STATE OF NORTH CAROLINA  
DEPARTMENT OF TRANSPORTATION

Subject: Revised Application for USACE General Permit 31 and Section 401 Water Quality Certification, for the proposed improvement of NC 211 from west of NC 906 (Midway Rd.) to east of NC 87 in Brunswick County. TIP No. R-5021. WBS 41582.1.1.

Reference: NCDOT permit application dated July 23, 2018.

**PERMIT DRAWING SHEET 5 OF 95**

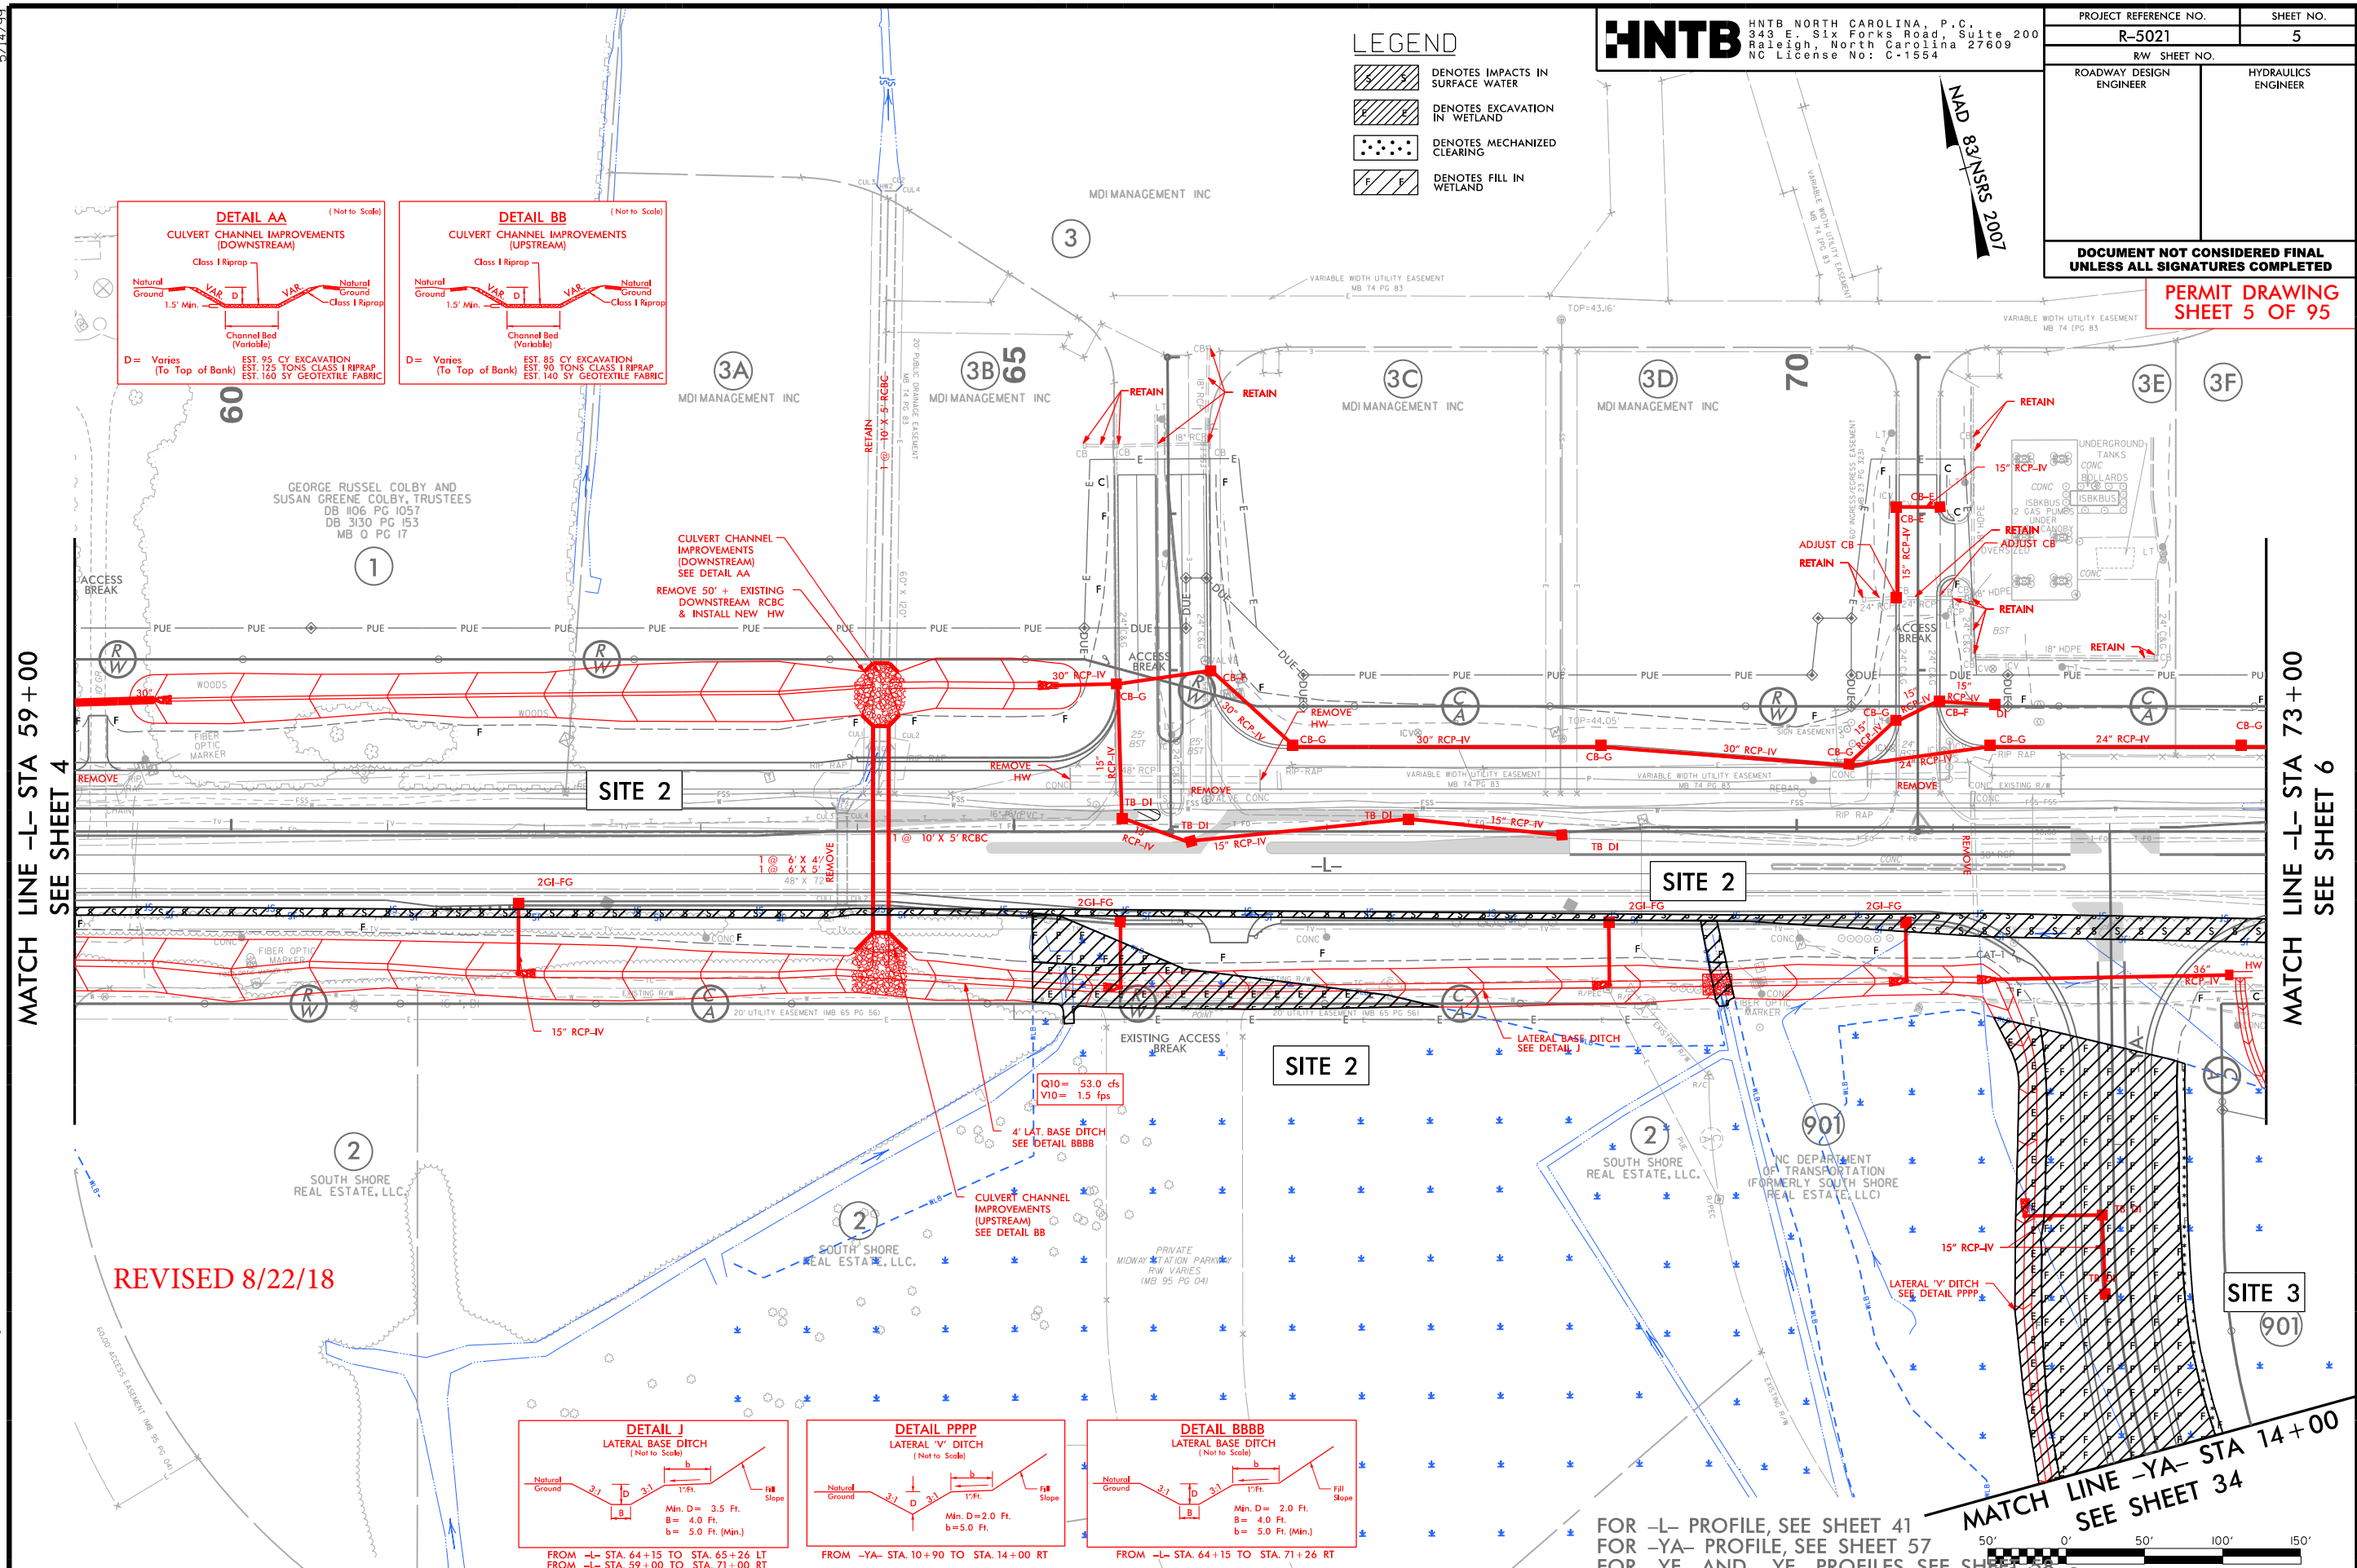
- Permit Drawing Sheets 5 and 6, Site 2: Detail BBBB for Sta. 64+15 to 71+26 RT (encompasses Site 2) has been added to Sheets 5 and 6 to match the proposed ditch depth shown on cross section 70+50.00 (Sheet 7).

- Permit Drawing Sheets 5 and 6, Site 3: A 2 ft. ditch was not evaluated for drainage effect at this site. Therefore, an additional 0.11 acre of wetland excavation impact is now shown on the drawing and in the impact summary to account for the drainage effect from ditching.

PERMIT DRAWING  
SHEET 38 OF 95

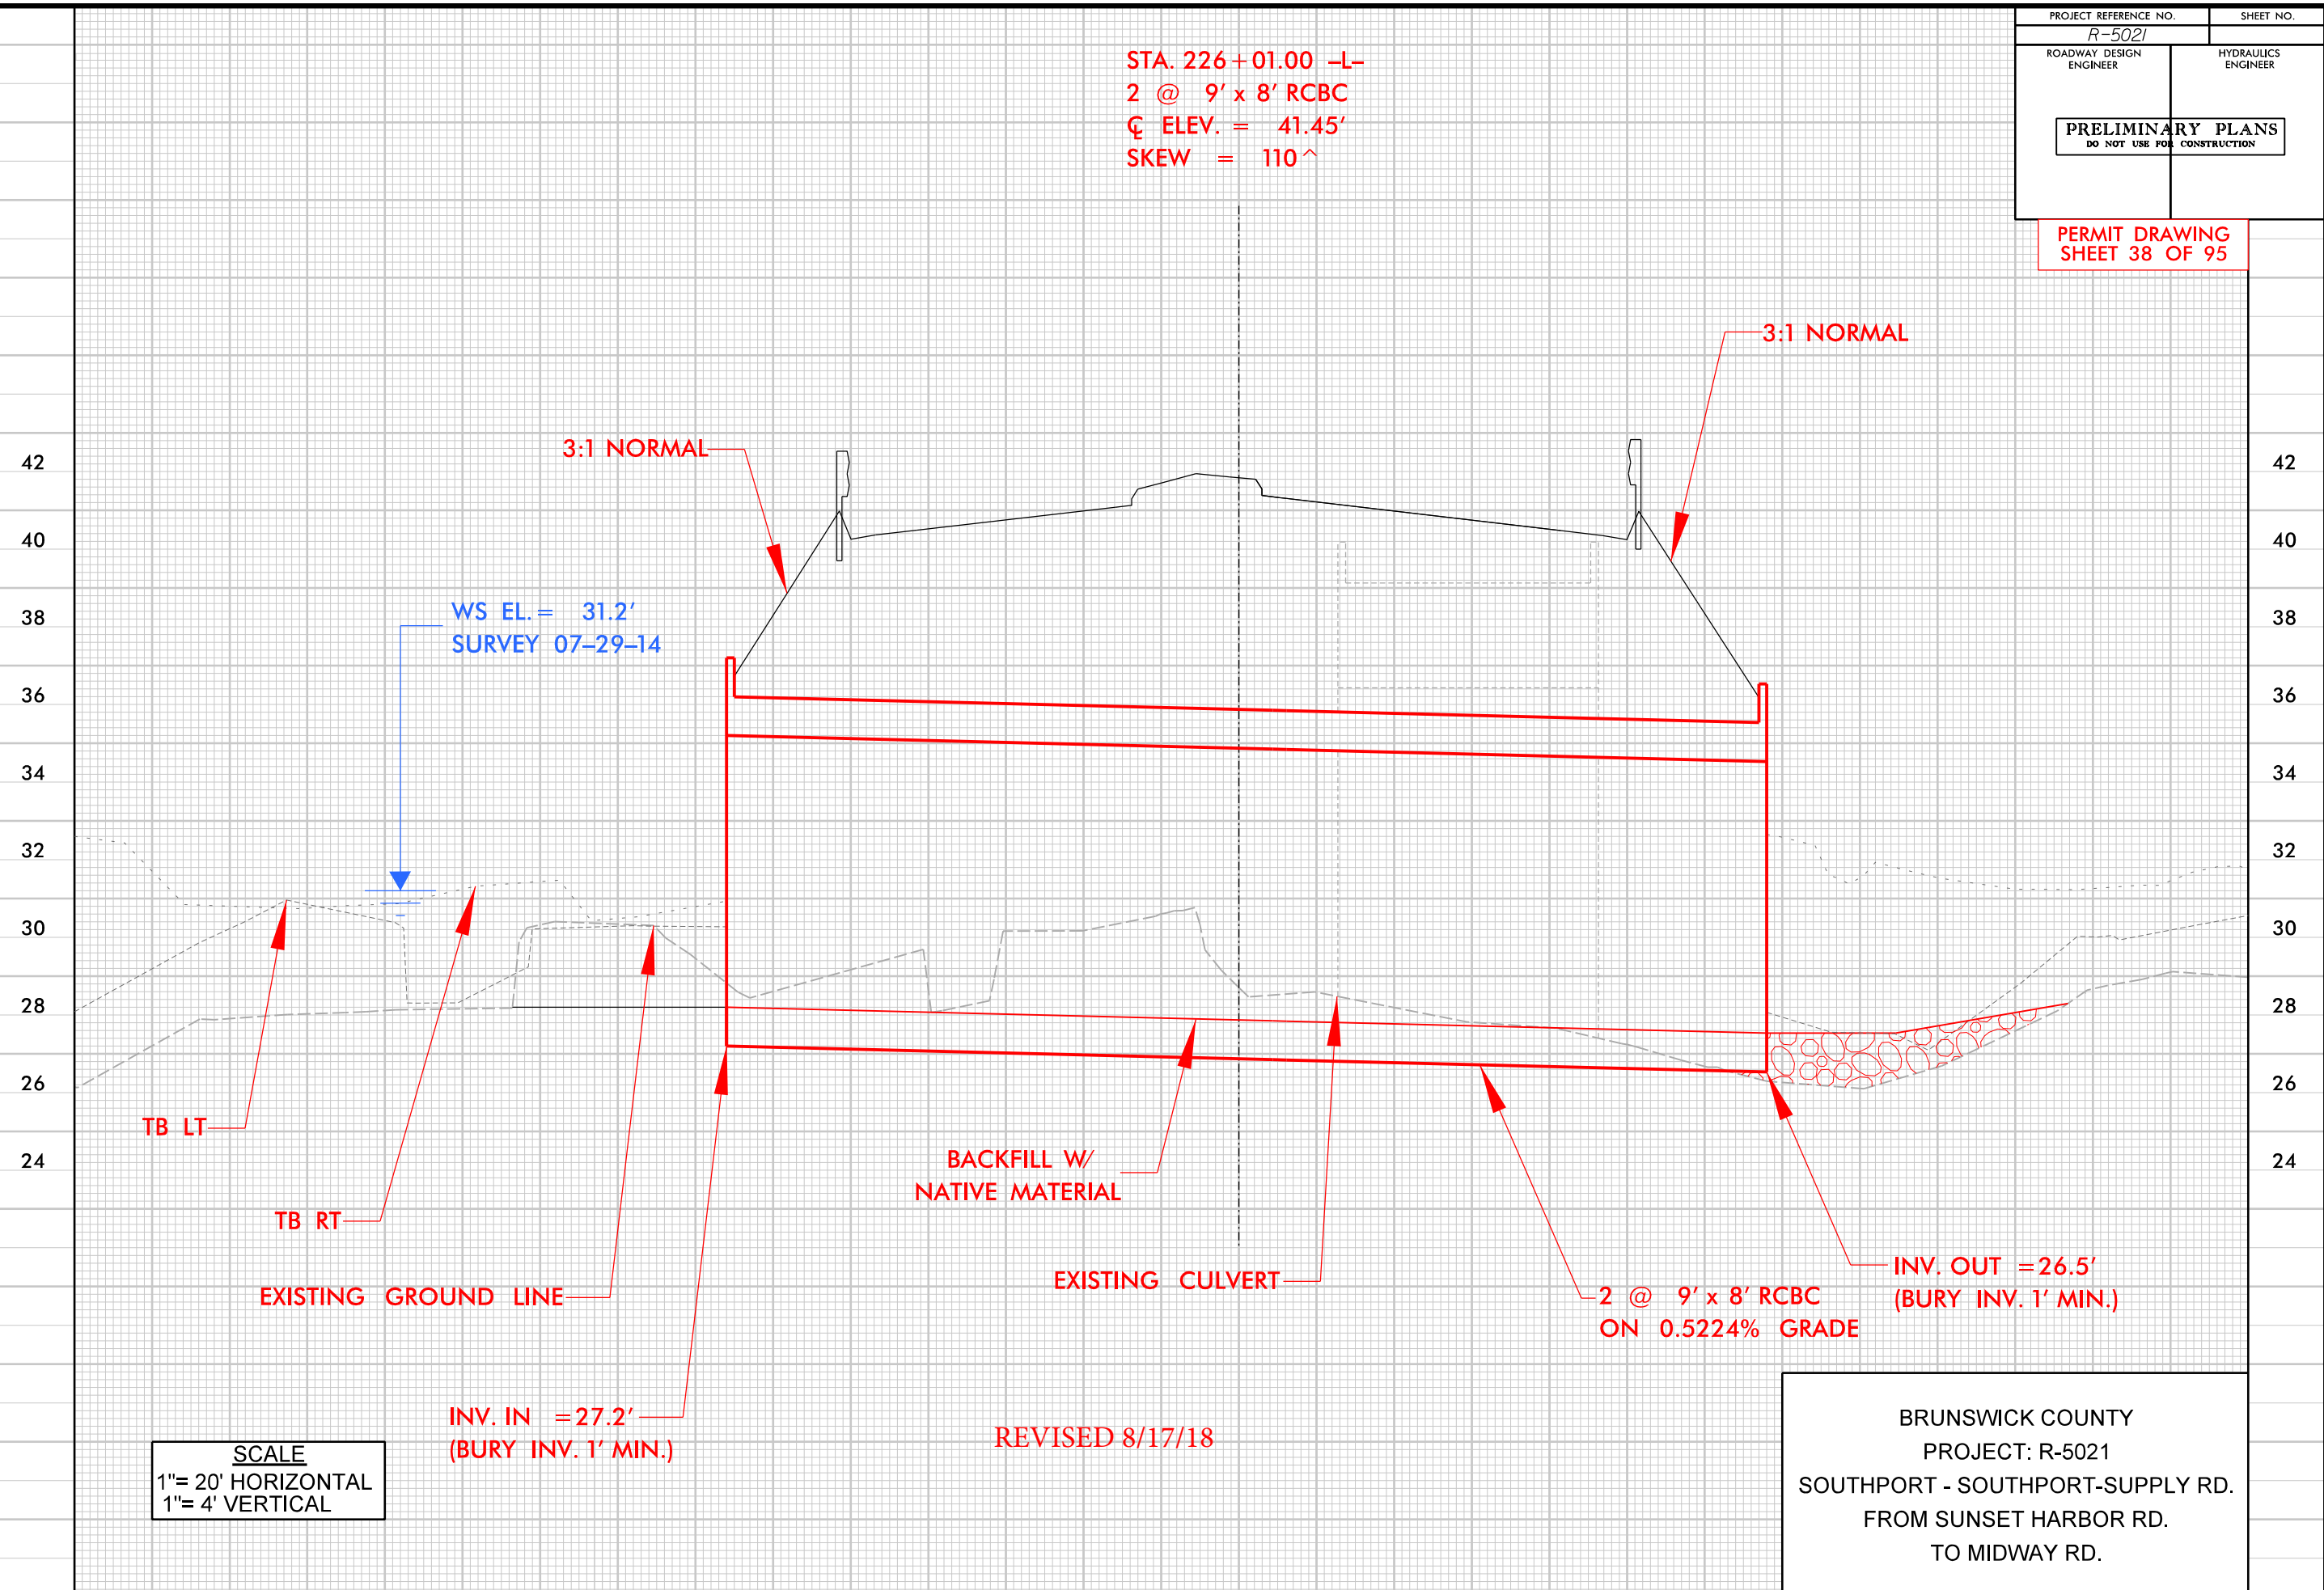
- Permit Drawing Sheets 18 and 19: Detail G (lateral base ditch) has been added to the drawing.
- Permit Drawing Sheets 38 and 61: invert 'out' originally shown as invert 'in' has been corrected.
